Technical Service Information

GM 4L65E

NUMBER FIVE CHECKBALL ELIMINATED

Figure 1

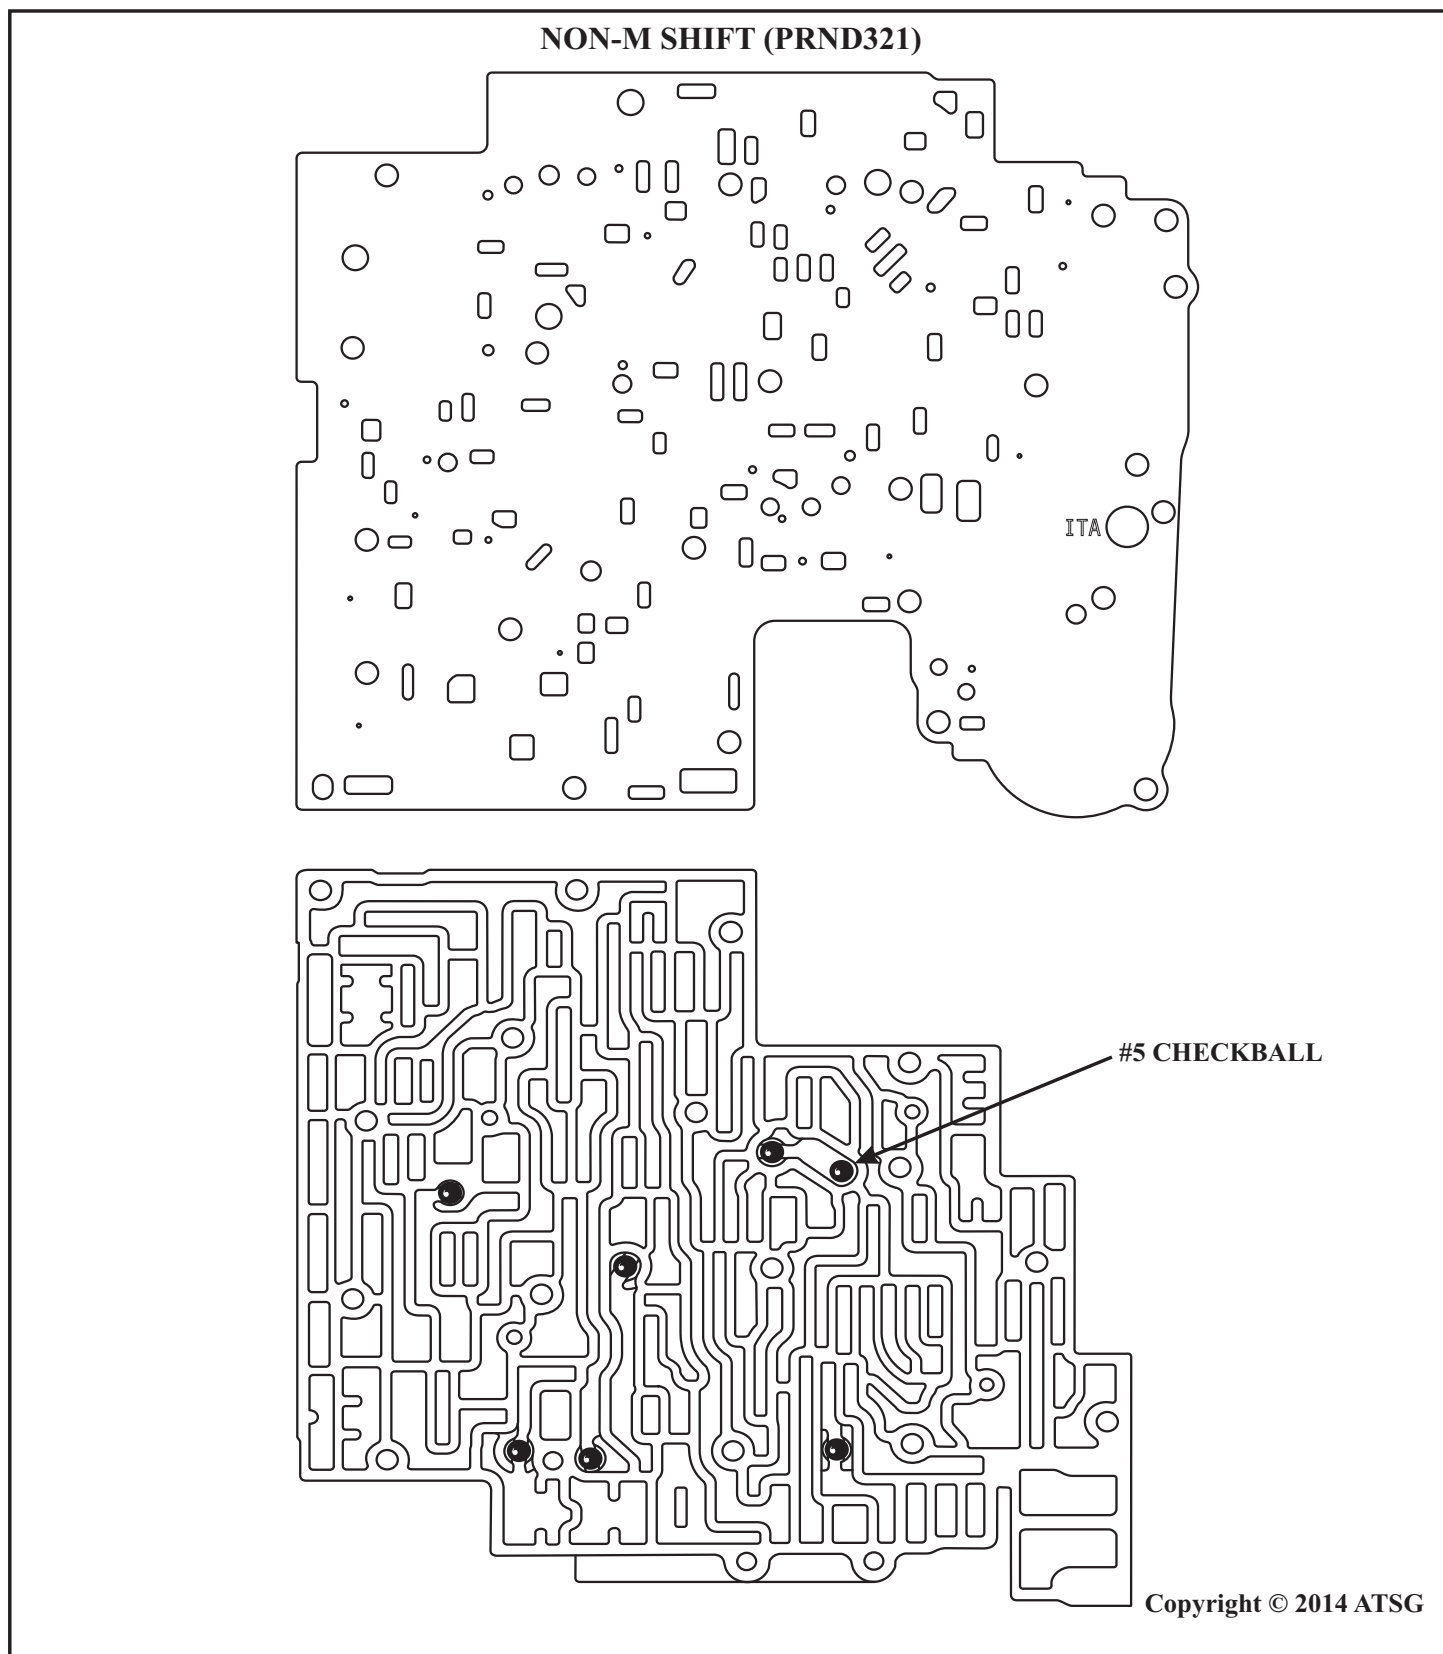
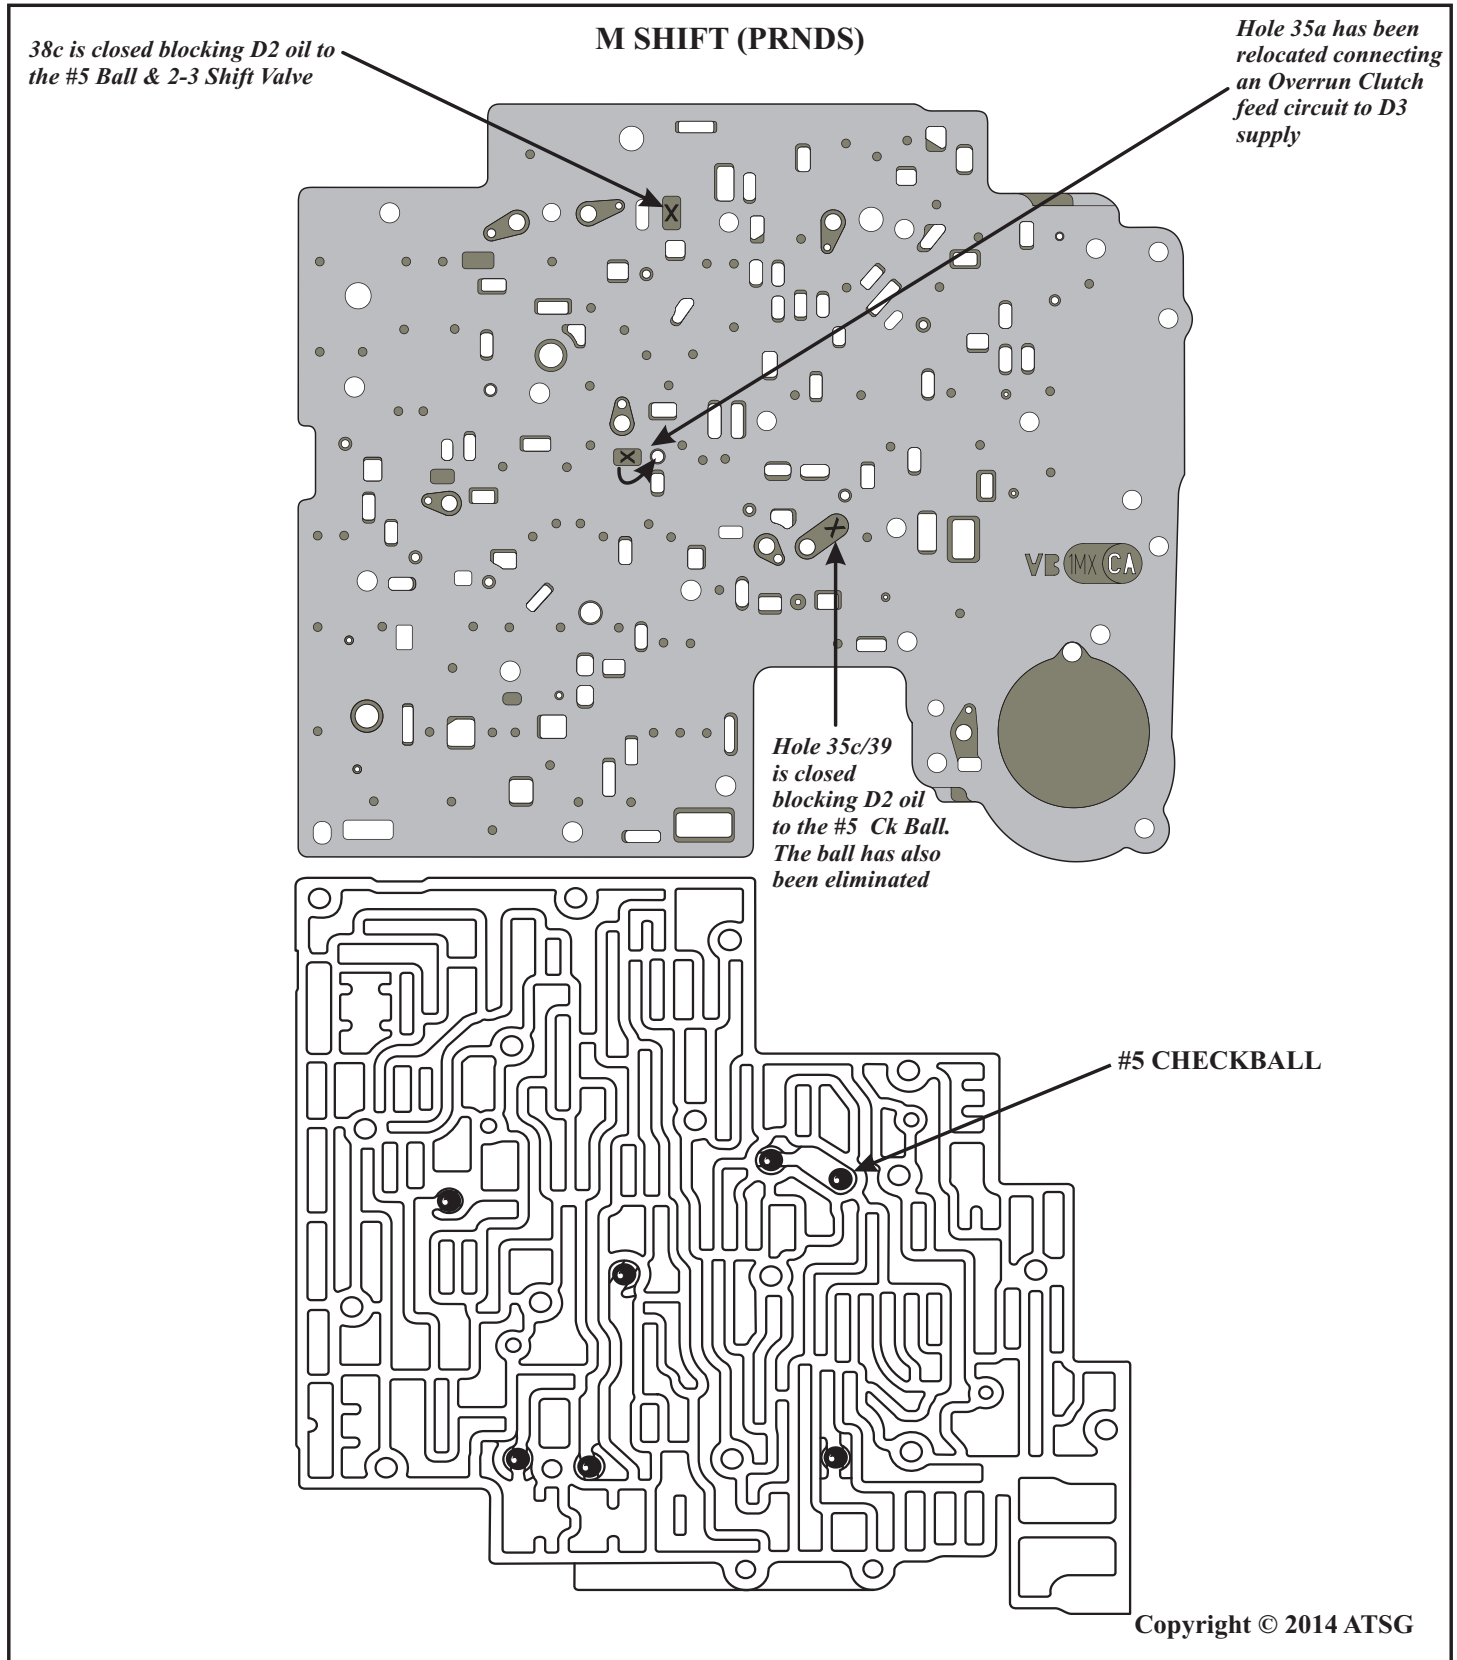
CHANGE: The Number Five (5) Checkball was eliminated and the valve body spacer plate was modified. The manual gear selector and its components have also been modified and paddle shifters have been added to provide manual up and down shift capabilities when the selector is in the “S” position. The shift indicator quadrant without the number five checkball will have PRNDS. The shift indicator quadrant for the conventional shift pattern is PRND321.

Figure 1 Is the spacer plate and Valve body checkball locations for the Non-M Shift Corvette. Figure 2 is the spacer plate used in the Corvette with the Manual Paddle Shift package. Using GM's Tech Guide numbering, hole 38c was blocked, hole 35c/39 was blocked, the number 5 ball is removed, and hole 35a was relocated. These changes blocked the D2 circuit to the 2-3 shift valve and the # 5 check ball (38c).

It connected Overrun Clutch feed to the D3 circuit (35a), which was routed through the revised # 5 check ball circuit. With the ball eliminated and the D2 hole blocked (35c/39), it forces the Overrun Clutch feed to be metered past the # 6 ball passing through the 4-3 sequence valve to apply the clutch. This configuration allows for D3 oil to immediately charge the Overrun Clutch circuit when the M range is selected by the driver for 1st, 2nd and 3rd gears. When a shift into 4th occurs, Overrun Clutch pressure is exhausted at the 4-3 sequence valve.

Figure 5

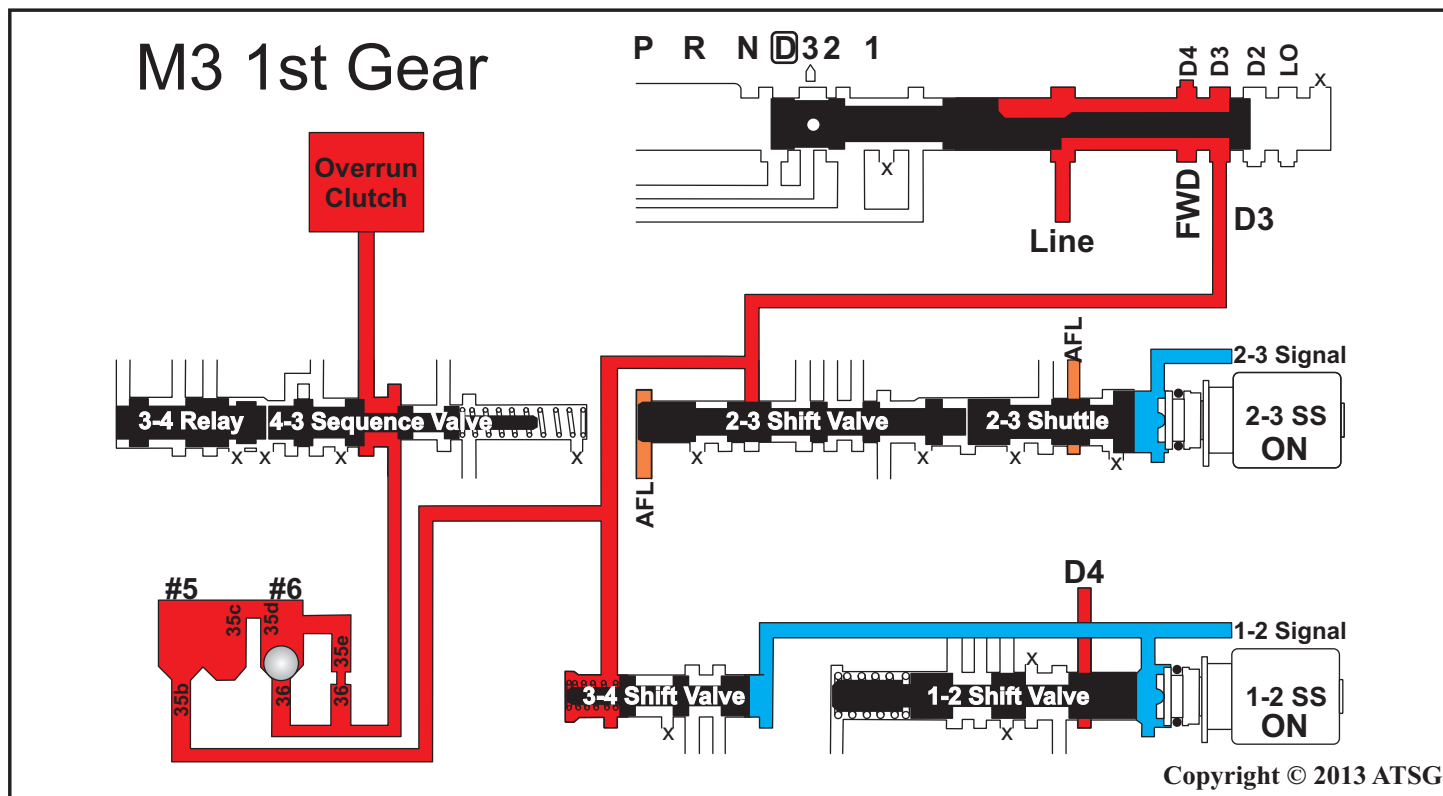
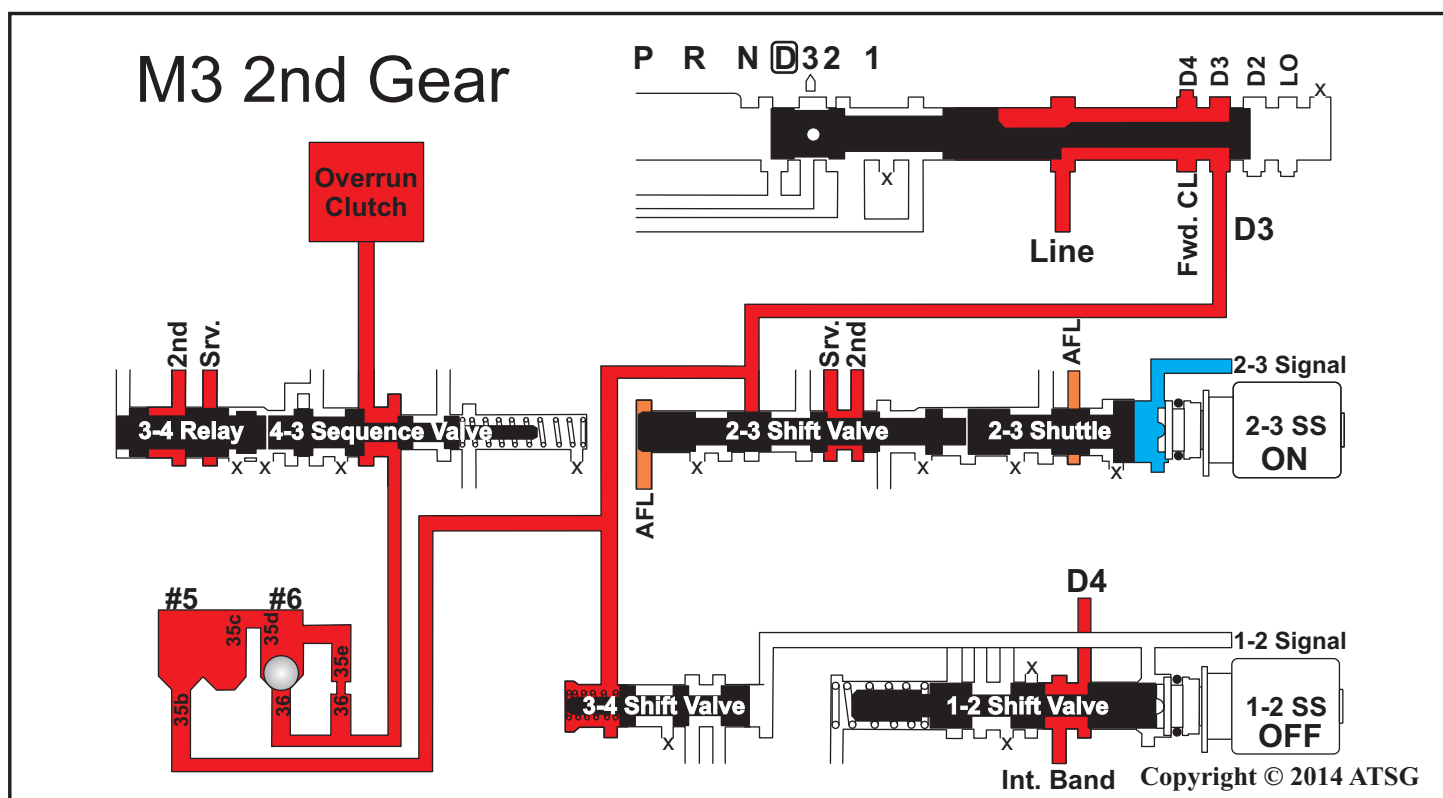
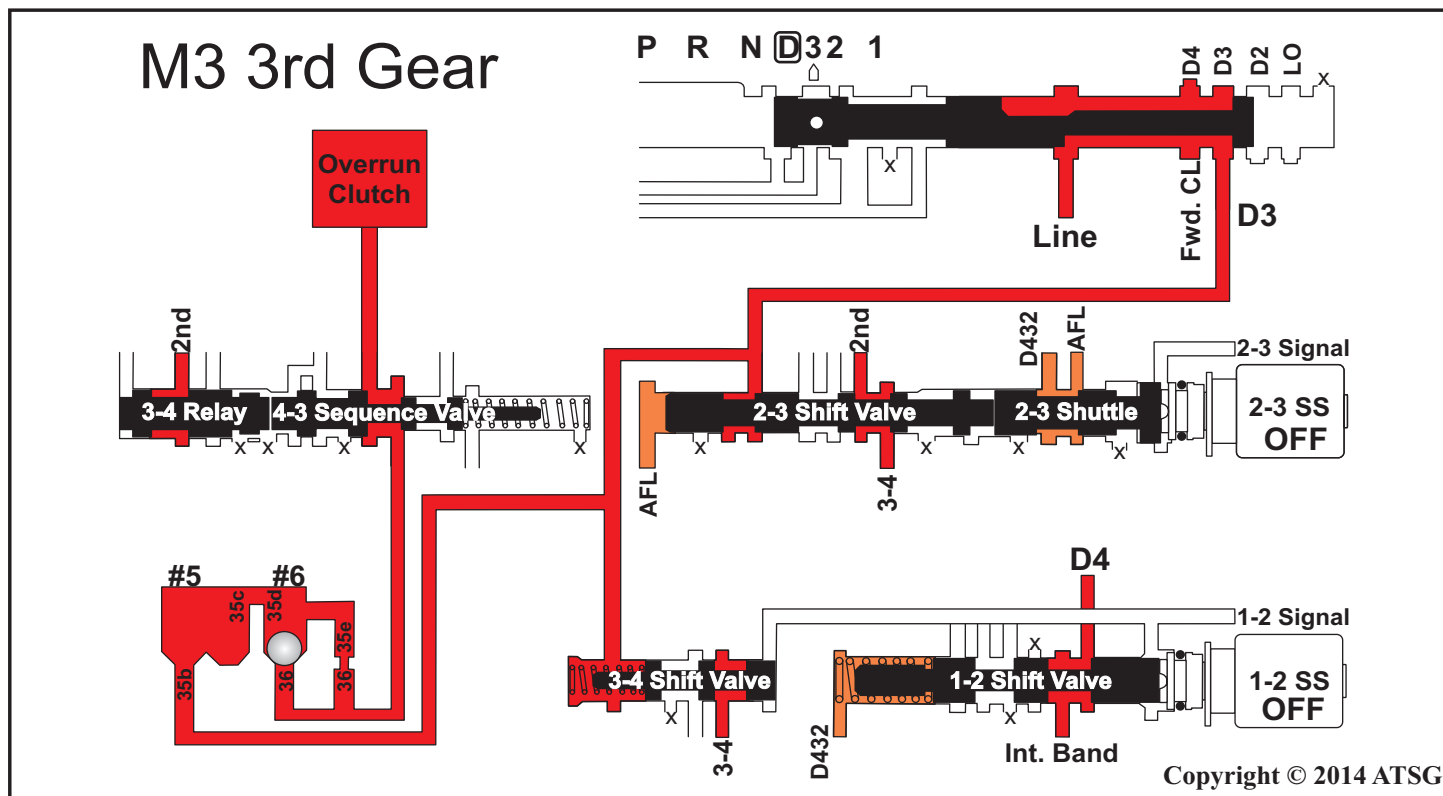
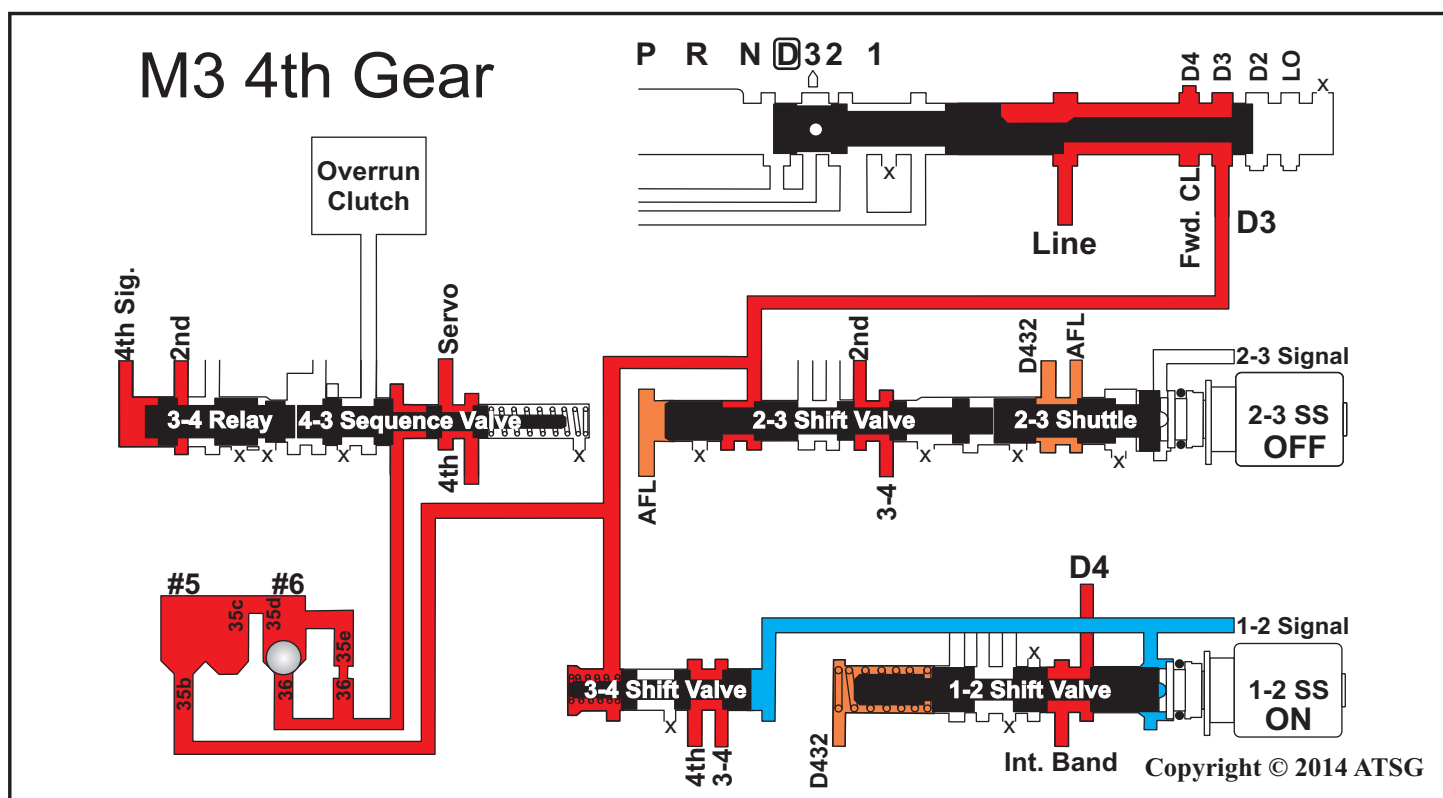
See figure 3 to compare the familiar non-M style hydraulics to the new M design seen in Figure 4. See figures 5-8 to see all 4 gears in the M position (Paddle Shift).
